## DEVELOPMENT APPLICATION ASSESSMENT REPORT

<b>Application Number:</b>	DA2024/0597
----------------------------	-------------

<b>Responsible Officer:</b>	Adam Croft
<b>Land to be developed (Address):</b>	Lot 10 DP 8172, 21 Oaks Avenue DEE WHY NSW 2099
<b>Proposed Development:</b>	Demolition works and construction of Shop top Housing
<b>Zoning:</b>	Warringah LEP2011 - Land zoned MU1 Mixed Use
<b>Development Permissible:</b>	Yes
<b>Existing Use Rights:</b>	No
<b>Consent Authority:</b>	Northern Beaches Council
<b>Delegation Level:</b>	NBLPP
<b>Land and Environment Court Action:</b>	No
<b>Applicant:</b>	Cite Developments No.2 Pty Ltd

**Figure 4. Indicative position of road link between Oaks Avenue and Pacific Parade**

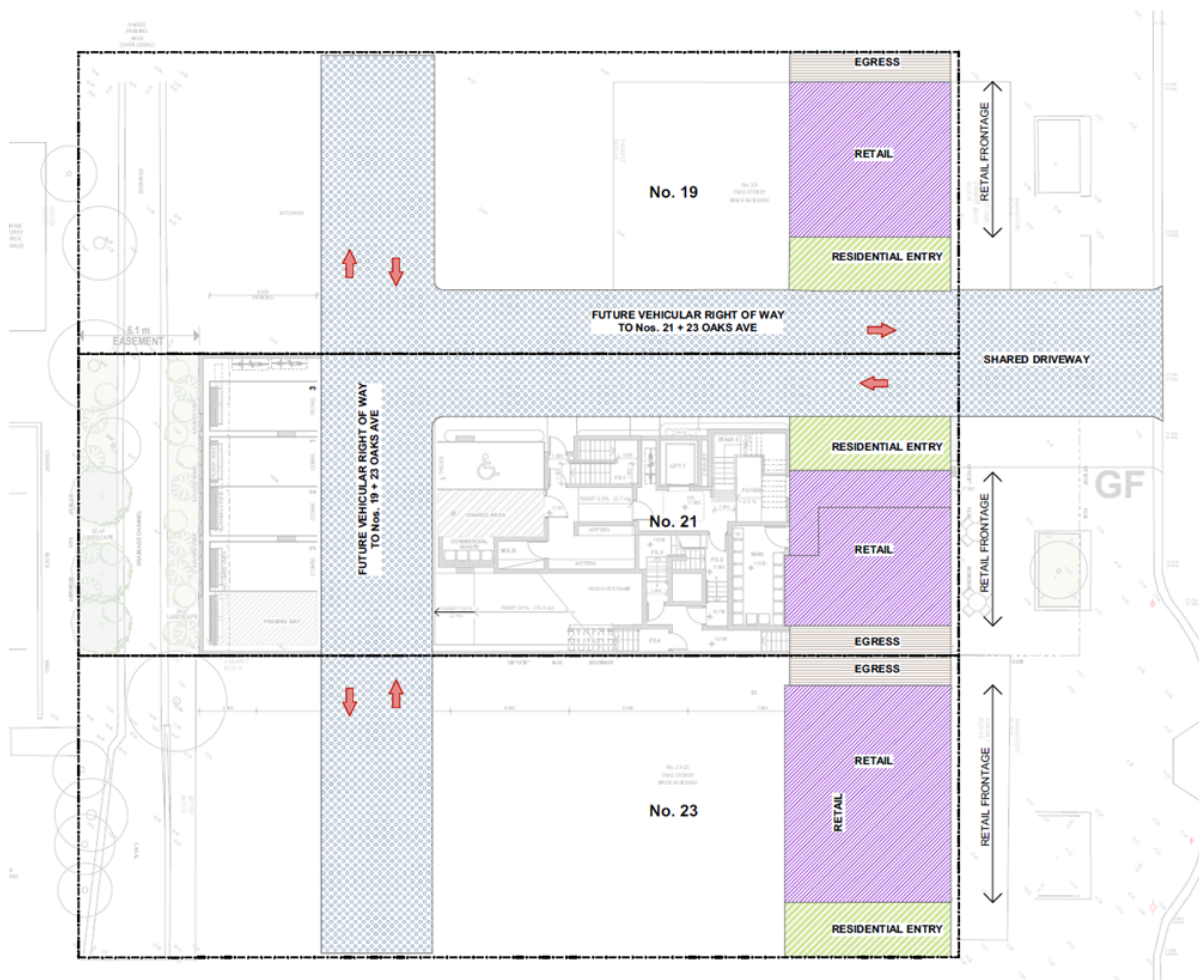
While it may be feasible for 23 Oaks Avenue (eastern adjoining site) to be consolidated with 33 Oaks

Avenue (Key Site C), the Key Site includes provision for a proposed new road linking Oaks Avenue to Pacific Parade, the indicative position of this road is between 23 Oaks Avenue and the majority of 33 Oaks Avenue (refer to Figure 4).

The road linkage may pose issues for the consolidation of the eastern adjoining site with Key Site C.
